Access Compliance Report

Public Rights-of-Way

(Curb Ramps)

Intersection ID: 19654	Main Street: CANYON_TL	Cross Street: ROBMONT_RD	Location: NE
ADA ID: 642B6F50D08A	Ramp Type: PerpDiag	Initial Pass/Fail: Fail	Overall Compliance: No
		Severity Score: 25

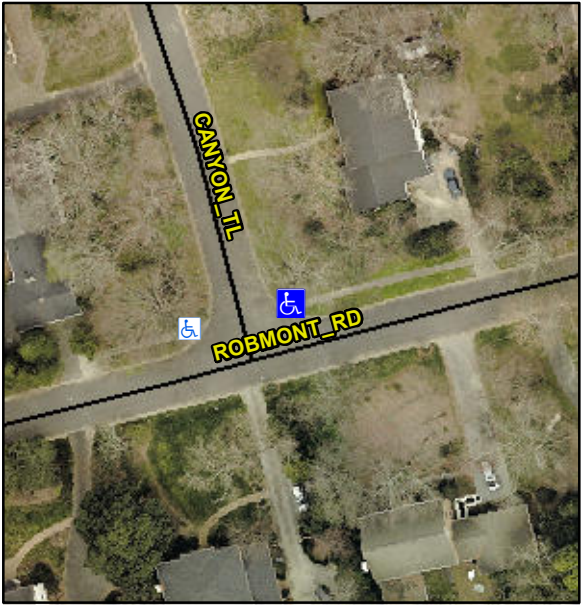
Codes/Mitigation Info/Possible Solution			Field Measurements/Component Compliance		
	Possible Solutions:		Compliance	Description	Data
	Remove & Replace Curb Ramp With Two New Directional Ramps or Equivalent.		N/A	Ramp Length (in)	36.0
			Yes	Ramp Width (in)	48.0
			N/A	Flare Type LT	N/A
			N/A	Flare Slope LT (%)	N/A
			N/A	Flare Traversable LT?	N/A
			N/A	Landing Length (in)	N/A
			N/A	Landing Width (in)	N/A
			N/A	Landing Slope (%)	N/A
			N/A	Landing X Slope (%)	N/A
<p>Surveyor Notes:</p> <p>N/A</p> <p>PROW/ADA:</p> <p>Not Found, R304.5.3</p>			N/A	Flare Type RT	N/A
			N/A	Flare Slope RT (%)	N/A
			N/A	Flare Traversable RT?	N/A
			N/A	DWS Provided?	N/A
			N/A	DWS Contrast?	N/A
			N/A	DWS Length (in)	N/A
			N/A	DWS Full Width?	N/A
			N/A	DWS Offset (in)	N/A
			N/A	Shared Landing?	N/A
			N/A	Gutter Ponding?	N/A
			N/A	Gutter Lip Ht (in)	N/A
			N/A	Painted X Walk1?	No
				X Walk 1 Direction	To W
			N/A	X Walk 1 Width (in)	N/A

X Walk 1 Slope (%)	2.7
				X Walk 1 X Slope (%)	1.1
			N/A	Ramp inside XWalk1?	N/A
				Road Slope (%)	3.3
				Road X Slope (%)	3.5
			N/A	Any Obstructions?	N/A
				Obstruction Type	
Total Cost:		\$ 3200.00			
			N/A		N/A
			Yes	Surface Condition? (G/P)	Good
